Issued: September 1, 2026

This Agreement pertains to the following project (“Project”): Crosby Park to Robinson Elementary, Federal Project No. TAP-9900(791).

DATE	REVISION
ADDENDUM 2-HANDRAIL & 24" FES

SIDEWALK HANDRAILING WITHOUT BALUSTERS

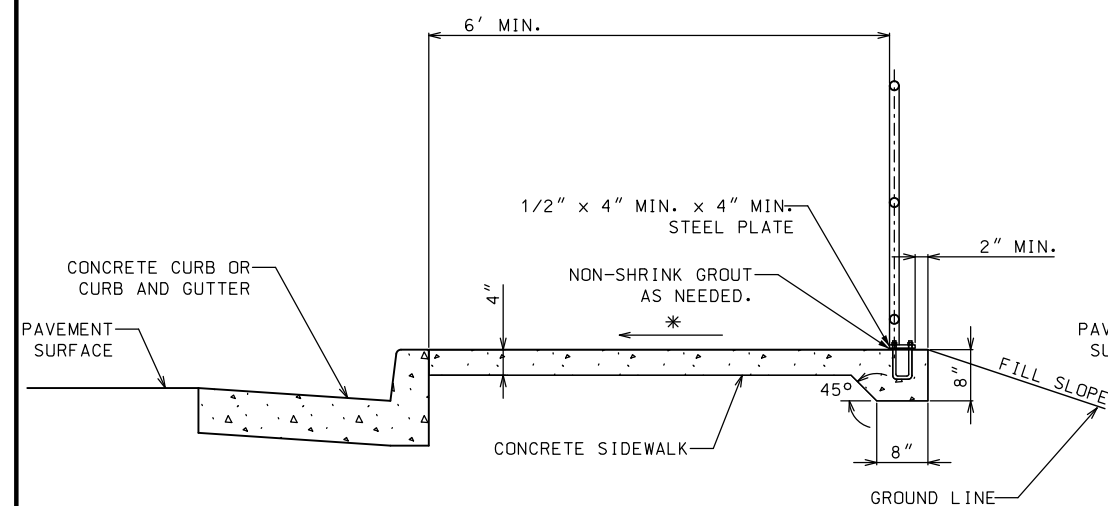
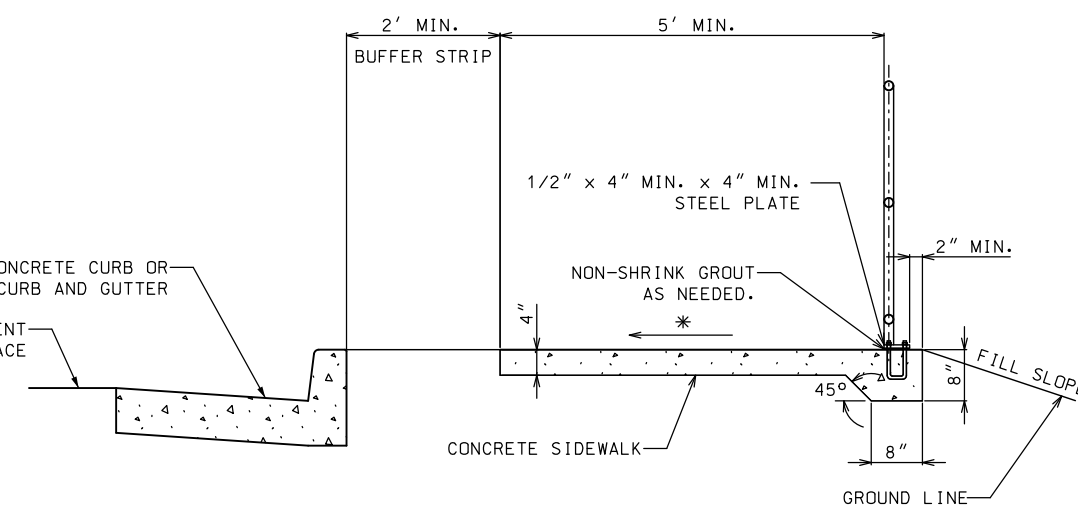
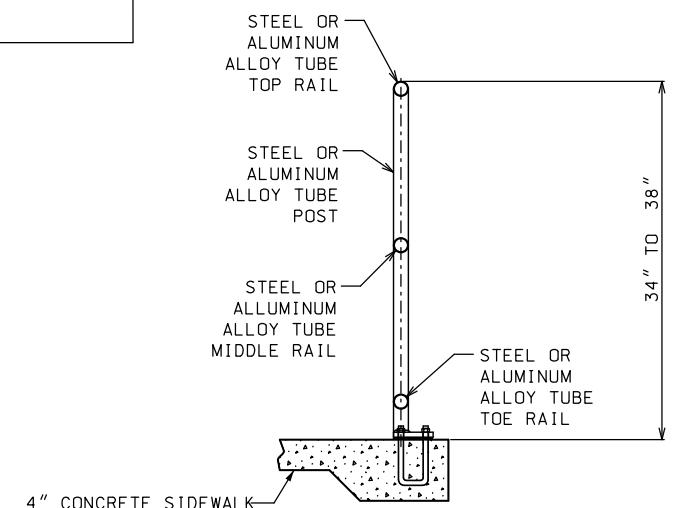
2. The bid schedule has been revised as follows. (A revised Bid Schedule is attached)
 - a. Item 8 has been removed and replaced with item 10, 608-40.23 Sidewalk Handrail. The corresponding MODOT standard details for this item are attached.

TRAIL PLAN
CROSBY PARK TO ROBINSON ELEMENTARY TAP-9900 (791)
CITY OF AURORA

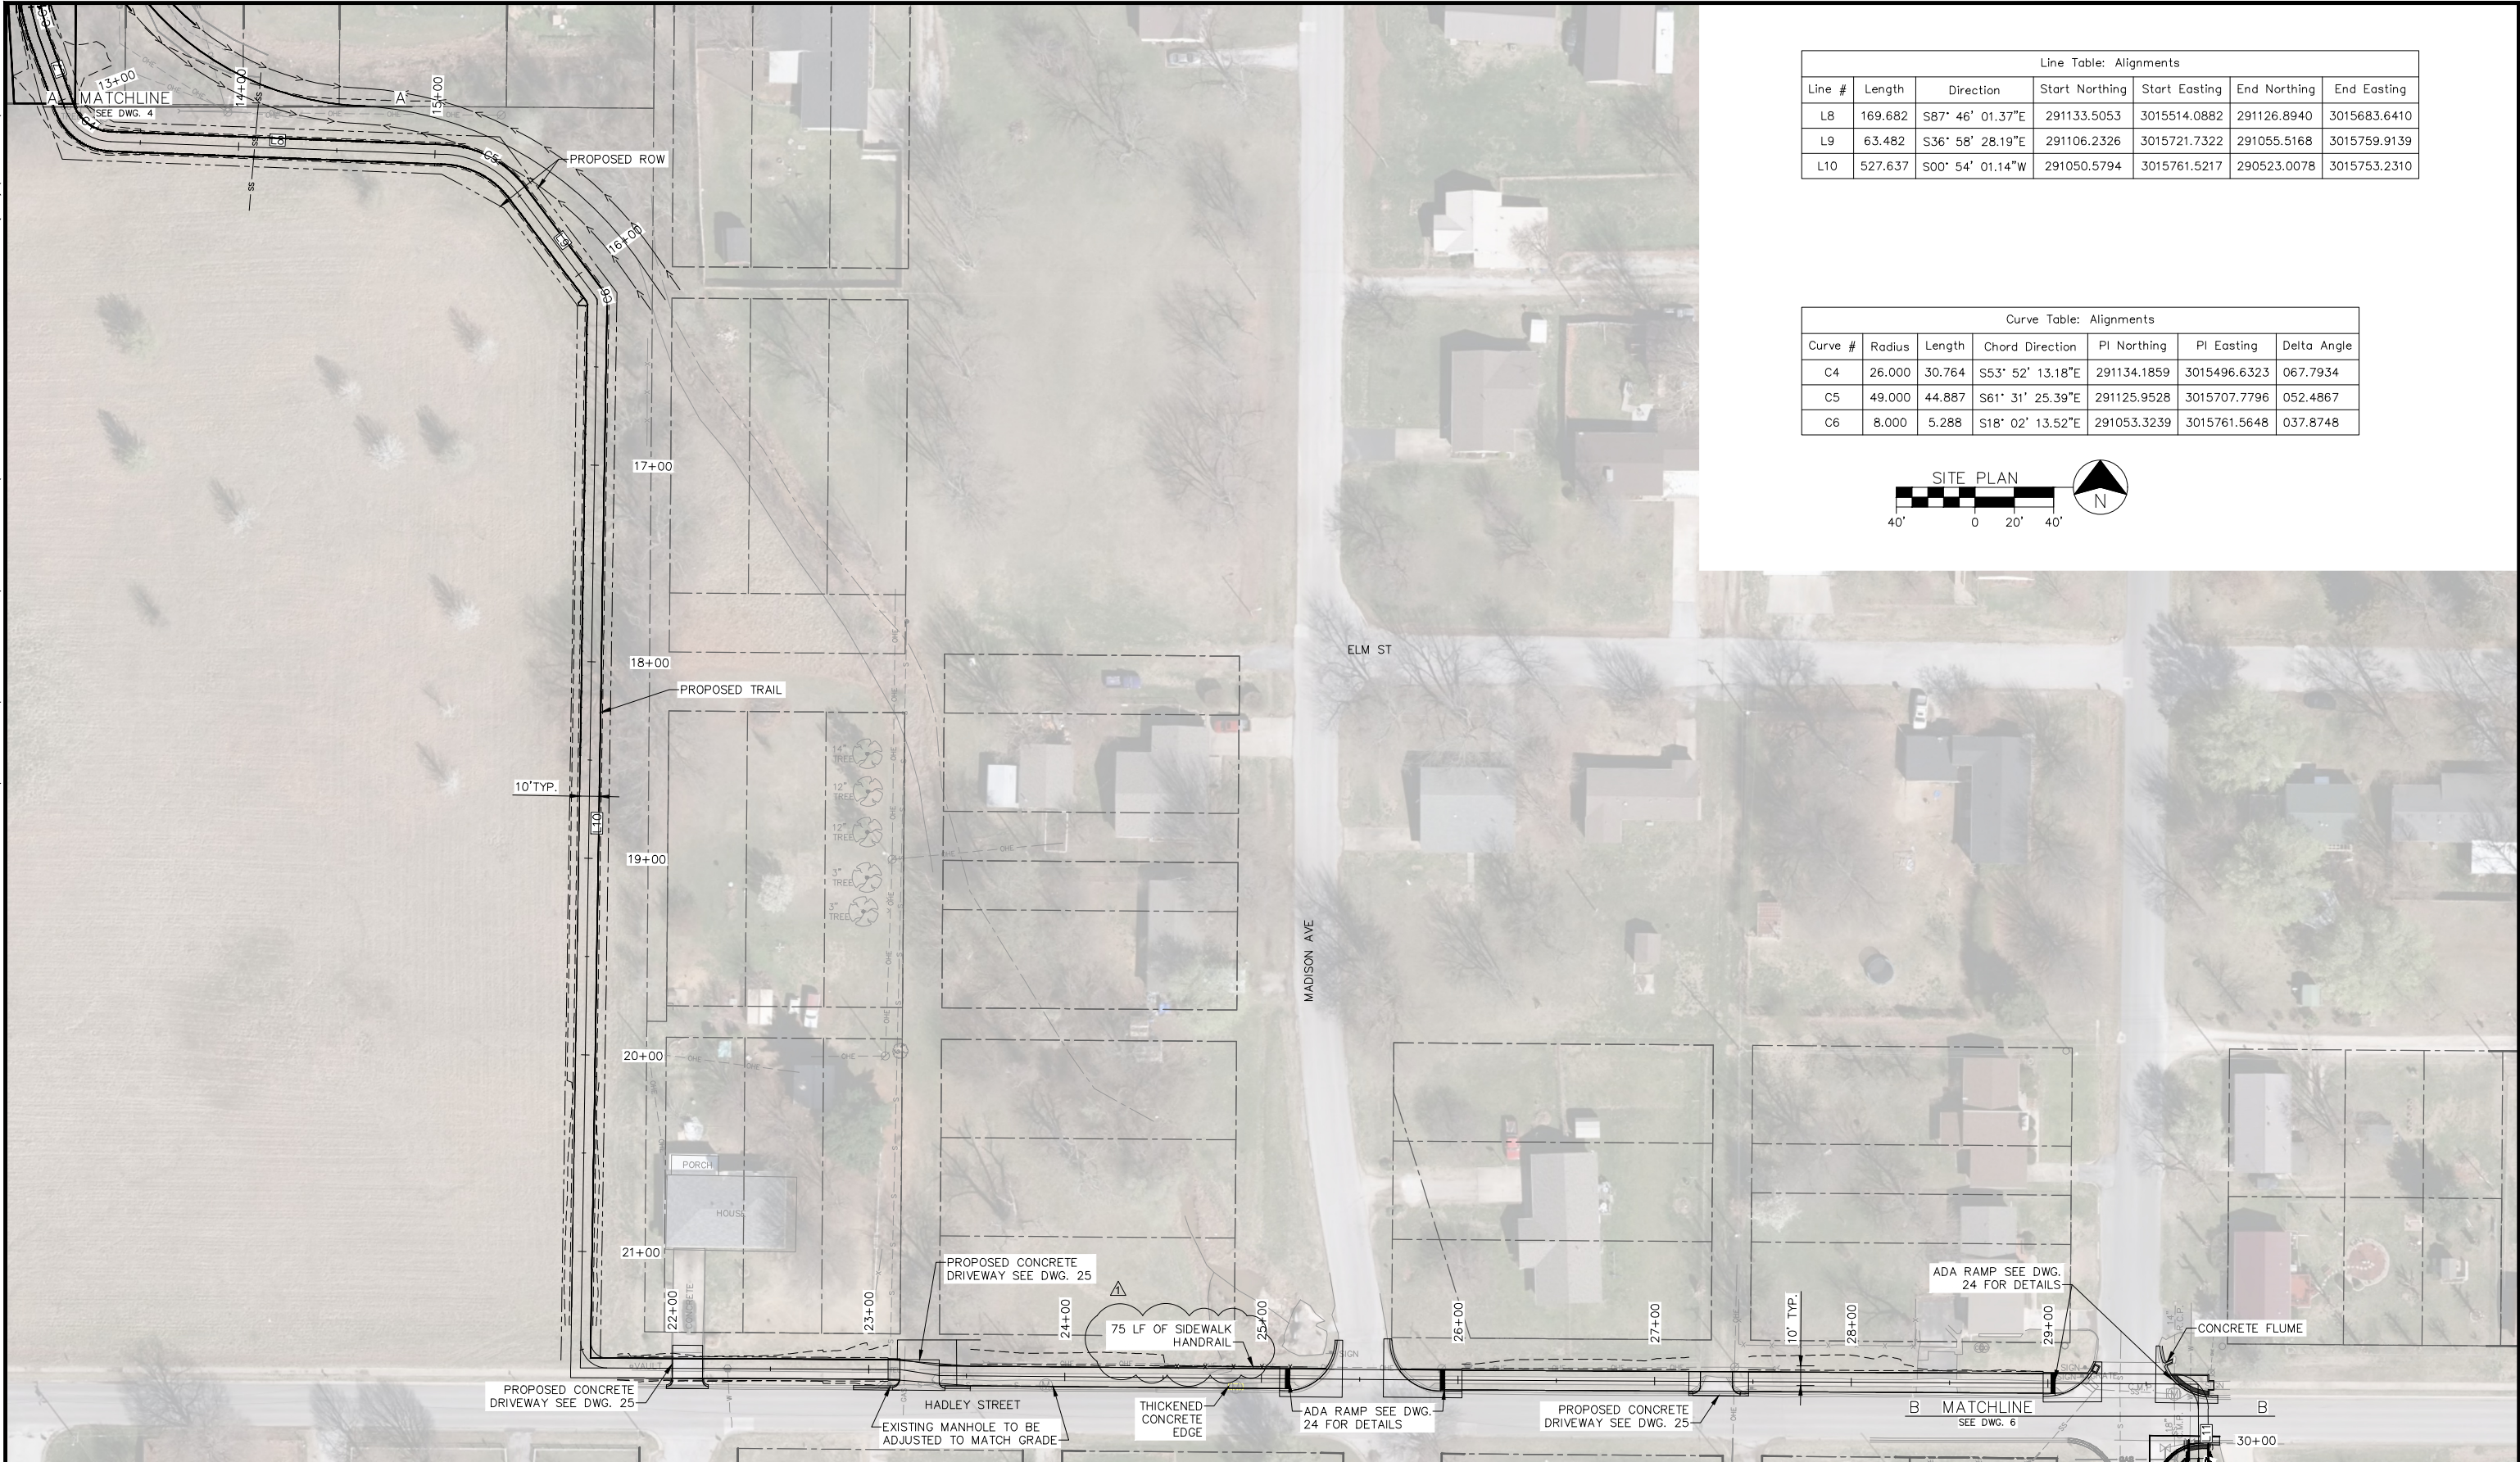
- a. Drawing 2: Updated Quantity Table.
 - b. Drawing 5: Replaced "75 LF OF BLACK VINYL COATED CHAINLINK FENCE" with "75 LF OF SIDEWALK HANDRAIL"
 - c. Drawing 6: Replaced "40 LF OF BLACK VINYL COATED CHAINLINK FENCE" with "40 LF OF SIDEWALK HANDRAIL"

DATE	REVISION
Δ	ADDENDUM 2-HANDRAIL
